# ADDENDUM NO. 1

**Armstrong Field  
815 Jefferson Street  
Three Rivers, MI 49093**

**A/E Project 5-5136**

**ADDENDUM 001**

STADIUM DEMOLITION  
PLAN

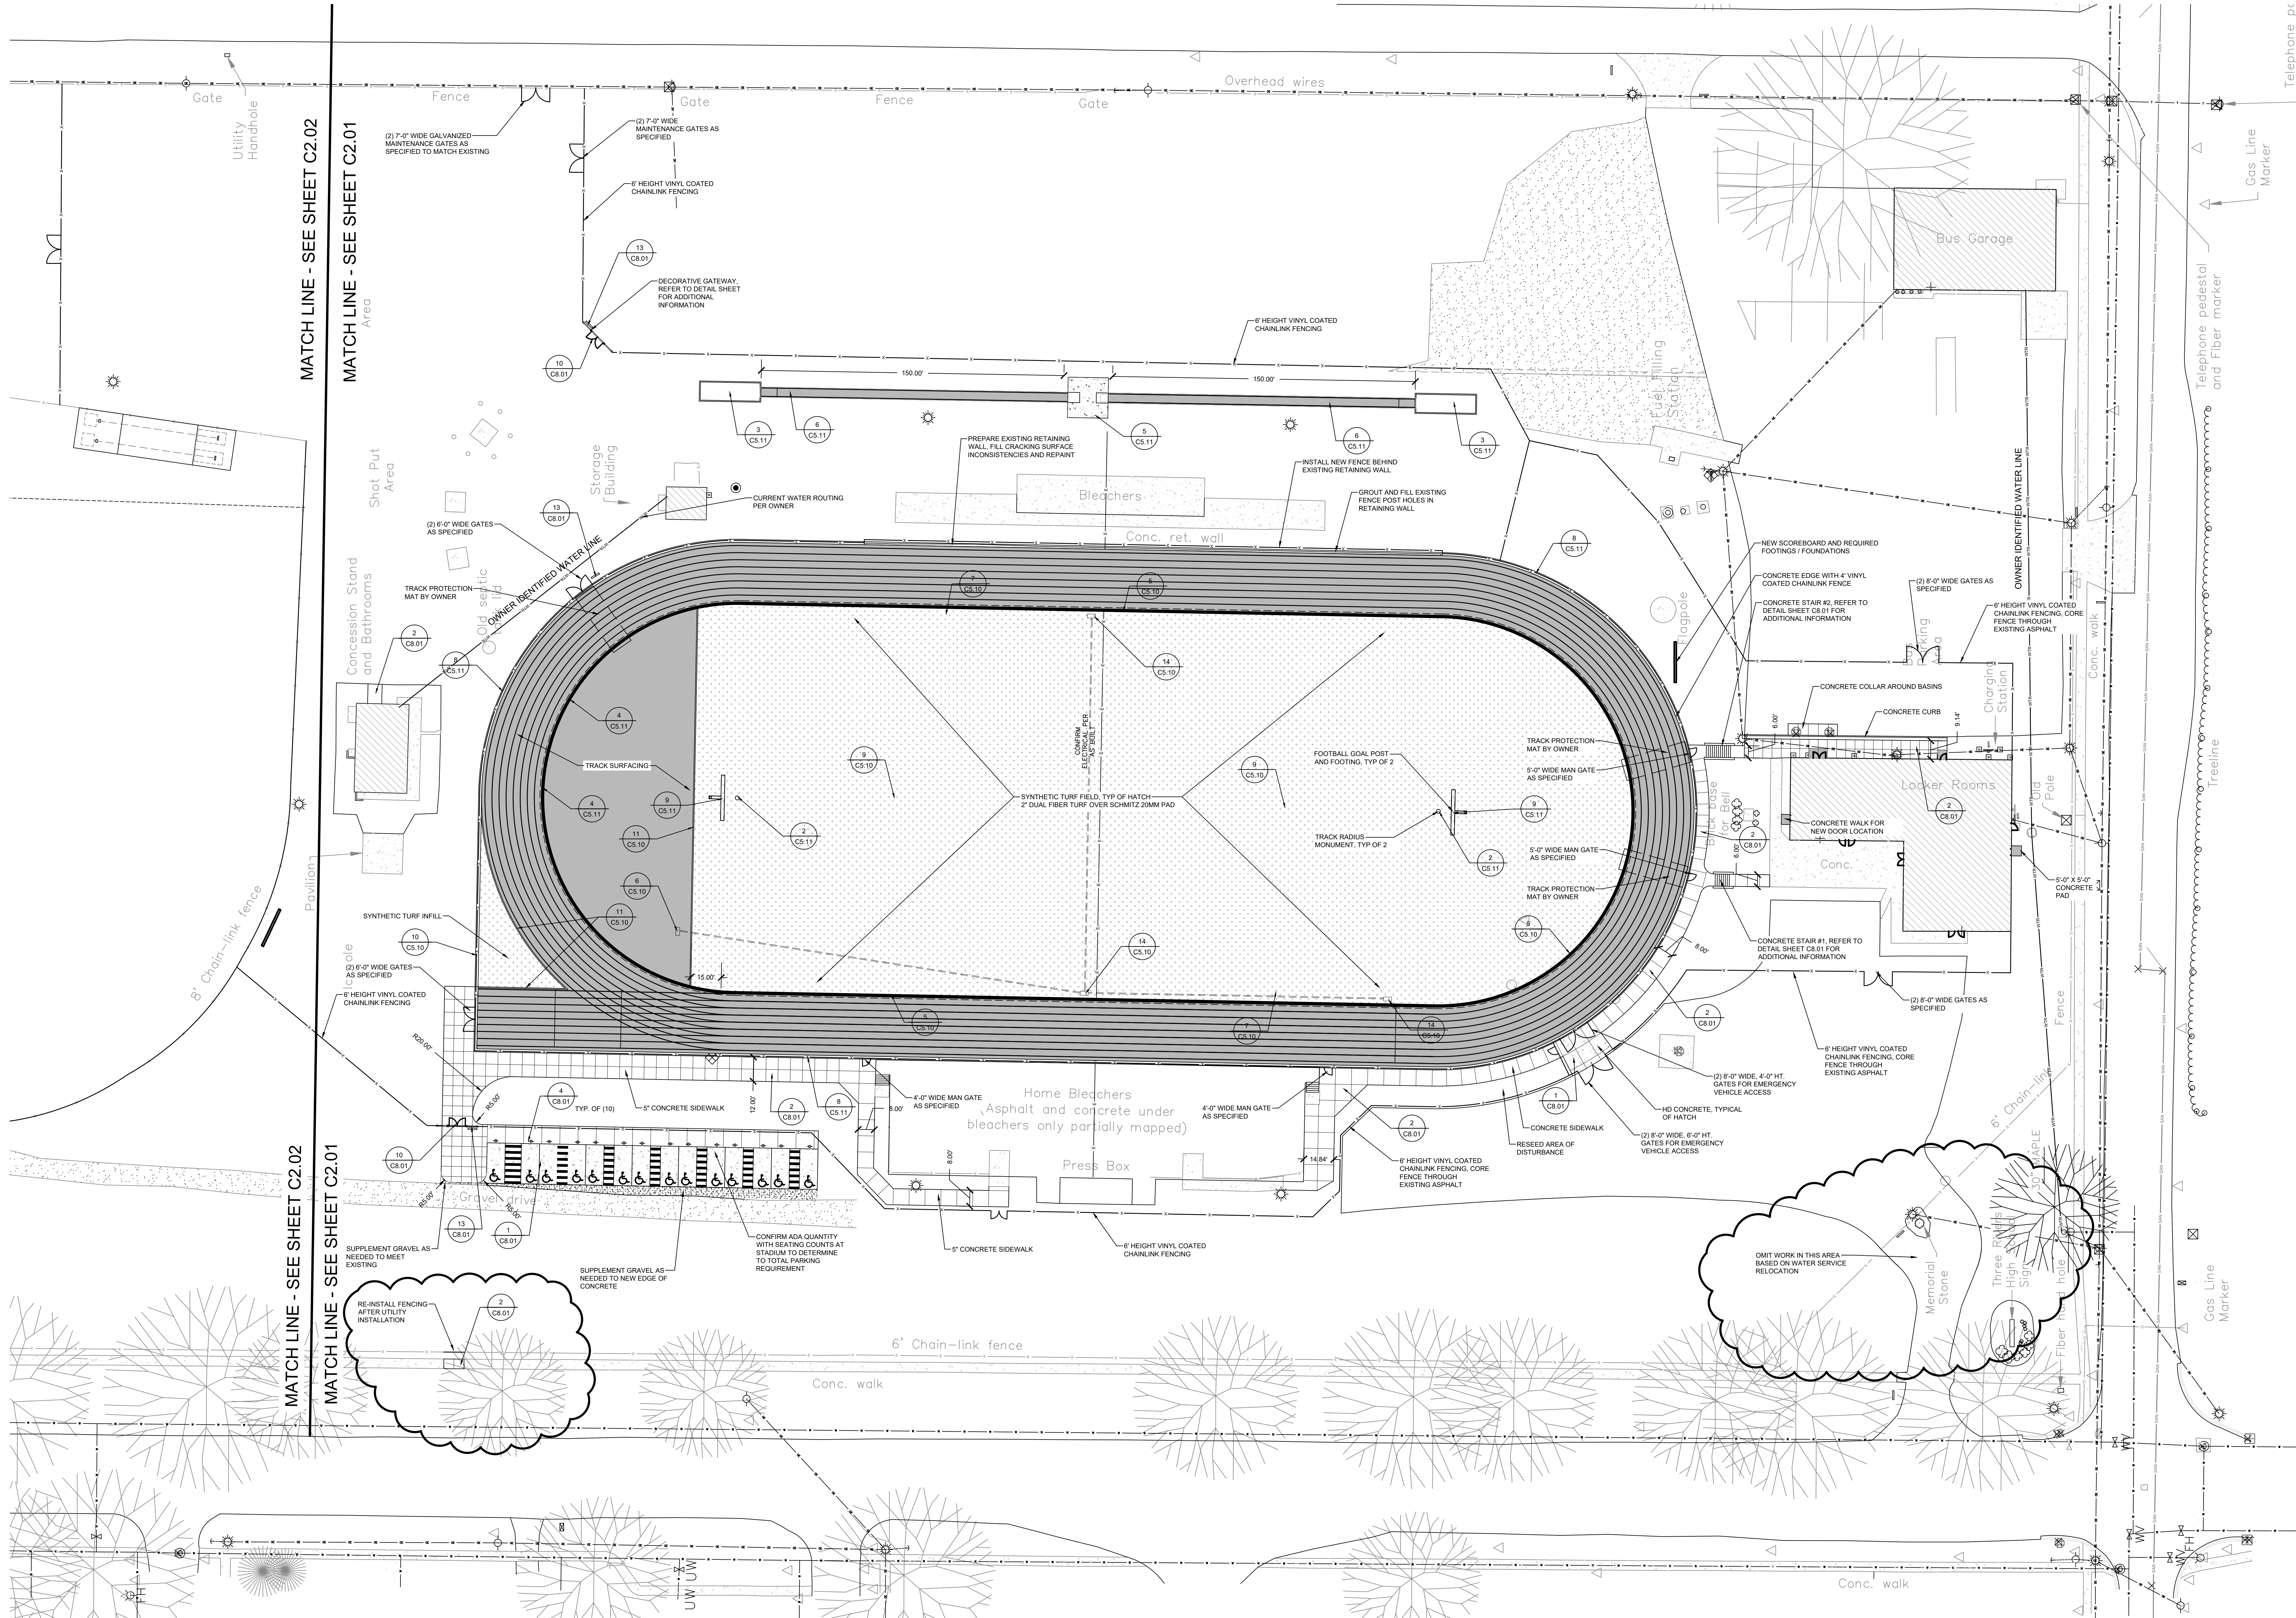
**ITEM NO. 1**      **SHEET C1.01 – STADIUM DEMOLITION PLAN (REISSUED)**

Refer to plan for updates to removals based on utility work.

STADIUM SITE PLAN

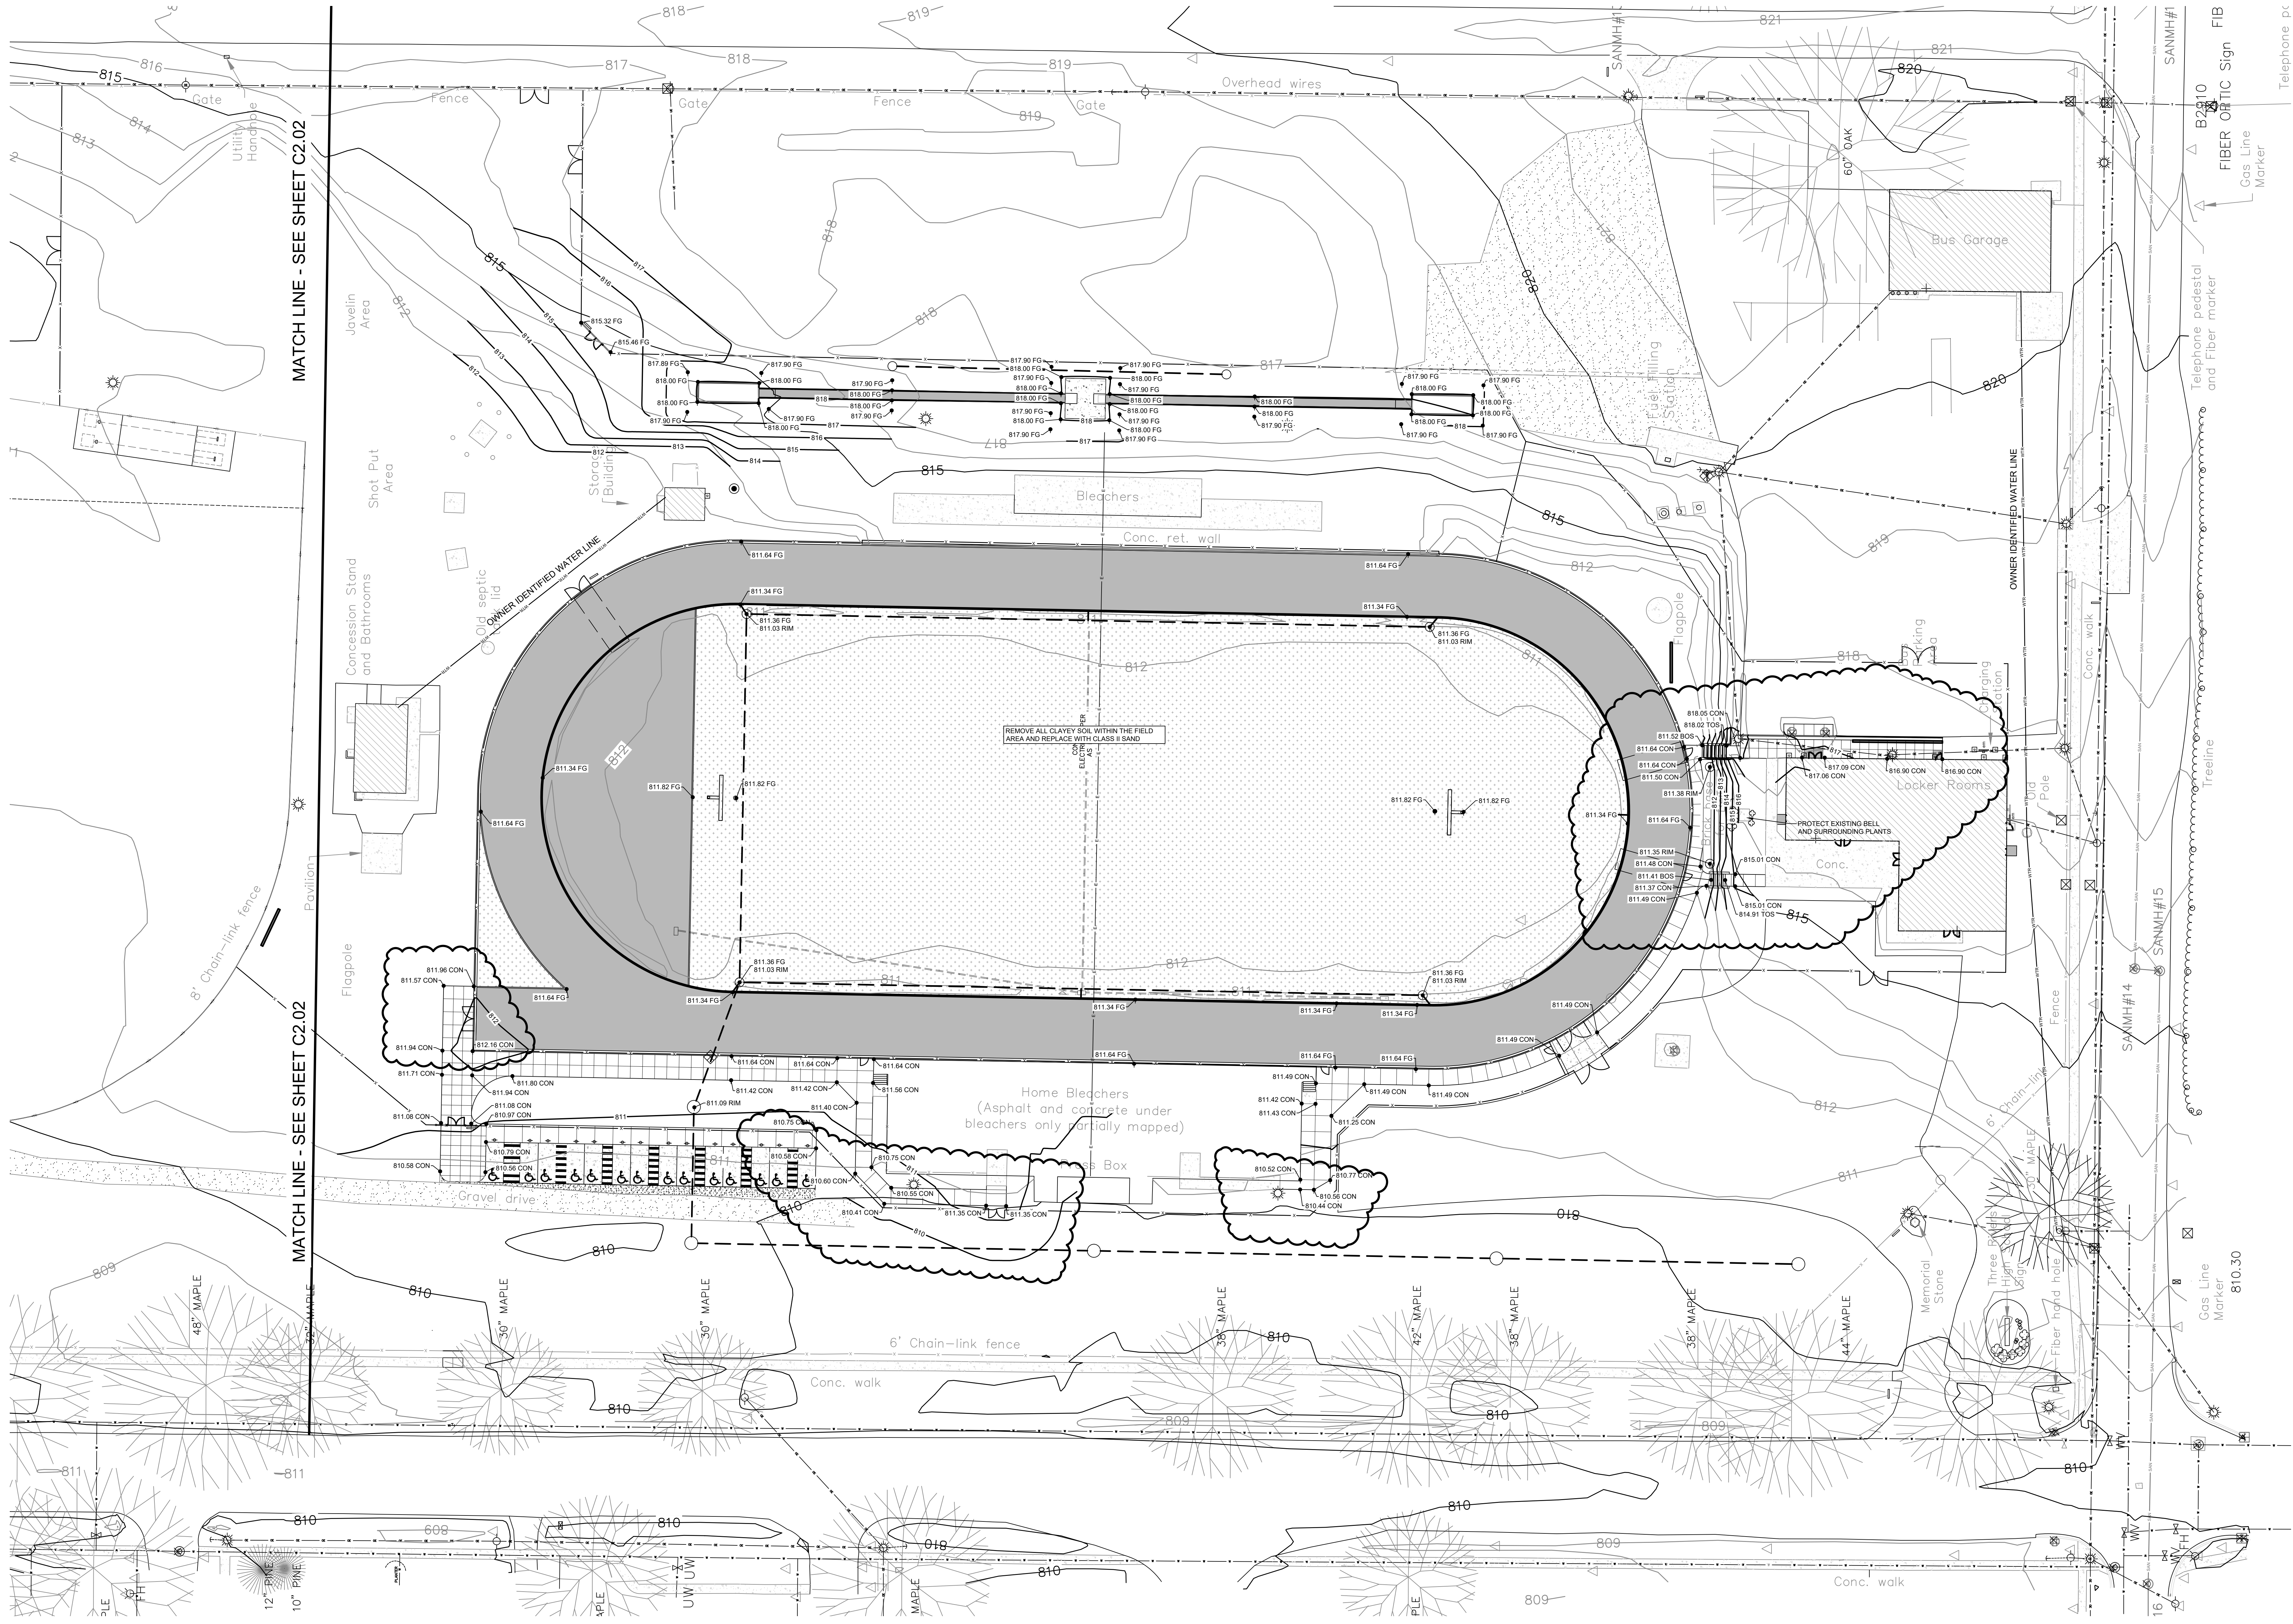
**ITEM NO. 2**      **SHEET C2.01 – STADIUM SITE PLAN (REISSUED)**

Refer to plan for updates to removals based on utility work.

STADIUM GRADING PLAN

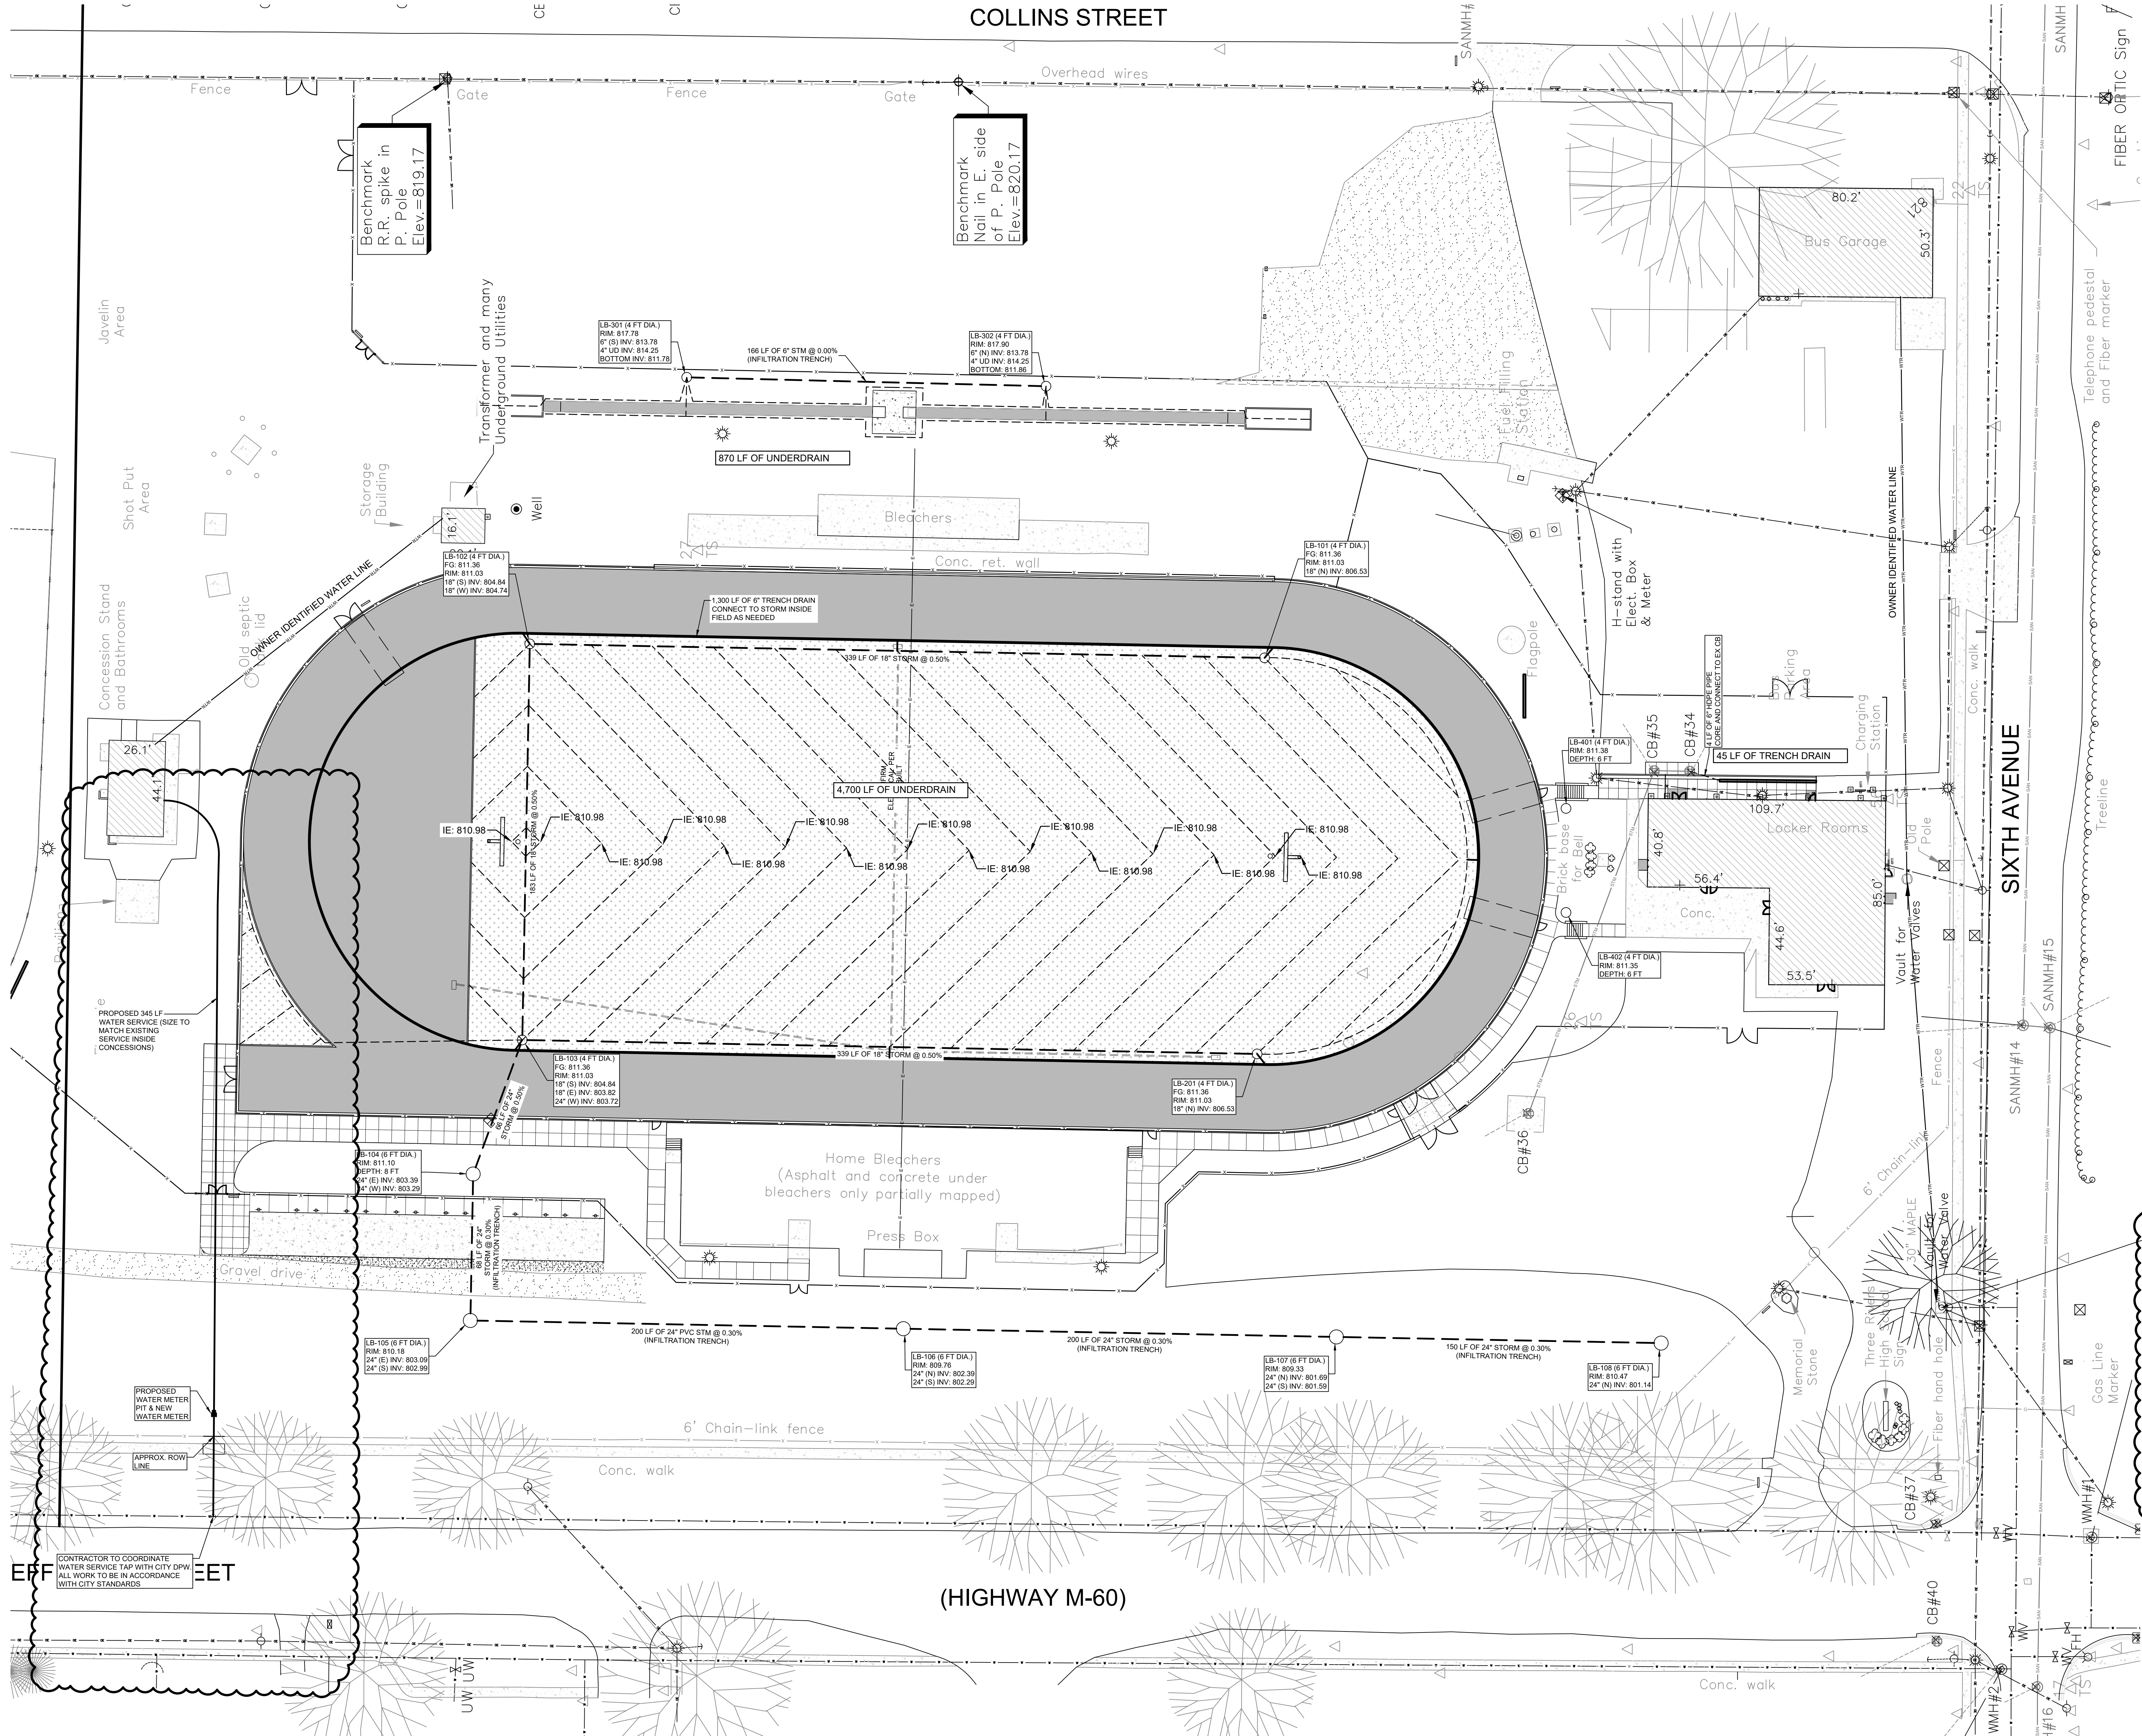
**ITEM NO. 3**      **SHEET C3.01 – STADIUM GRADING PLAN (REISSUED)**

Updated spot elevations and contours.
